PREPARED FOR THE PLAN COMMISSION

Project Address: 214 Waubesa Street (6th Aldermanic District, Ald. Rummel)
Application Type: Conditional Use
Legistar File ID # [46630](#)
Prepared By: Chris Wells, Planning Division
Report Includes Comments from other City Agencies, as noted
Reviewed By: Kevin Firchow, AICP, Principal Planner

Requested Actions: The applicant requests conditional use approval for a parking reduction to allow an existing building to be converted into a community center at 214 Waubesa Street; 6th Ald.

Map 1: On-Street Parking Restrictions and Off-Street Parking Options for the 214 Waubesa Street Site

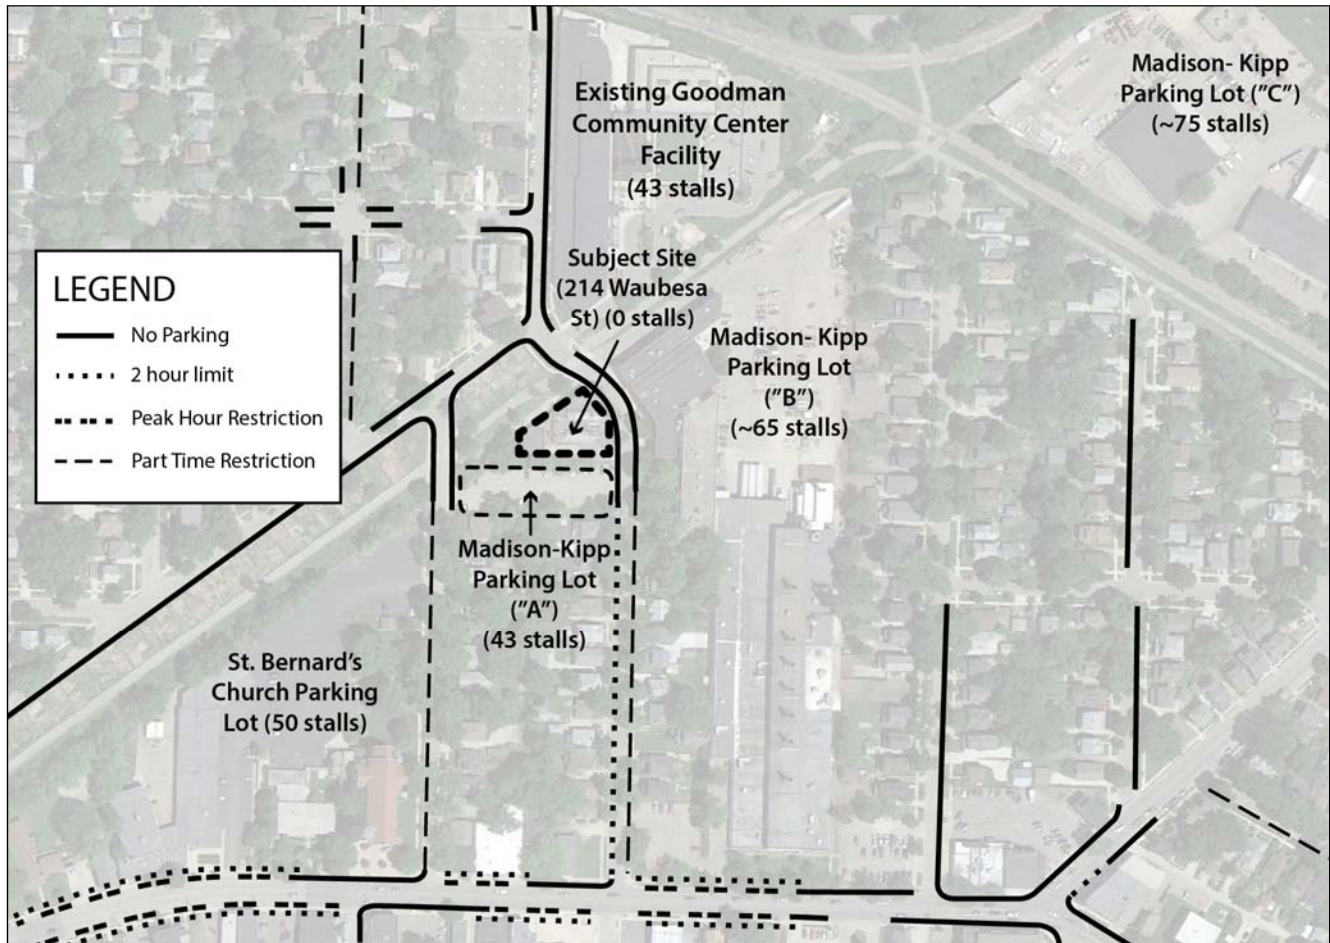
Availability of on- and off-street parking is depicted below in Map 1 (below). Staff acknowledge that on-street parking is limited. An examination of the on-street parking restrictions around the subject site (see Map 1 below) reveals several no parking/restricted zones on the surrounding streets. Note: there is no City Residential Parking Permit Program (RP3) for this neighborhood.

Regarding available off-street parking in the surrounding vicinity which can be used for event as well as overflow parking, the GCC has had, and plans to maintain, a formal agreement with the Madison-Kipp Corporation, who owns the parking lot immediately to the south (indicated on Map 1 (below) as *Madison-Kipp Parking Lot "A"*). This agreement allows the GCC to use six stalls during the day (the GCC currently park and plans to continue parking their vans in these stalls), and the entirety of the lot's 48 stalls starting at 4:30 pm on weekdays and all day on the weekends. (Note: revisions to that lot are currently before the Commission and if approved, the lot would be reduced to 43 stalls to meet applicable ordinance standards.) Three other large surface parking lots in the vicinity, which will provide stalls for overflow and event needs, are the roughly 65-stall Madison-Kipp lot located on the eastern side of the Madison-Kipp facility located across Waubesa Street from the subject site (indicated on Map 1 as *Madison-Kipp Parking Lot "B"*), the roughly 75-stall Madison-Kipp lot located to the east and across the railroad tracks from the existing GCC facility (indicated on Map 1 as *Madison-Kipp Parking Lot "C"*), and the 50-stall lot located to the west across Corry Street behind St. Bernard's Catholic Church. The GCC also has formal agreements in place with St. Bernard's Church as well as Madison-Kipp detailing the use of these lots. While the GCC has the Church's approval to use all 50 stalls at any time (unless notified otherwise by the Church about a specific event), the GCC is required to request approval from Madison-Kipp to use lots "B" and/or "C" (this is typically done for large events).
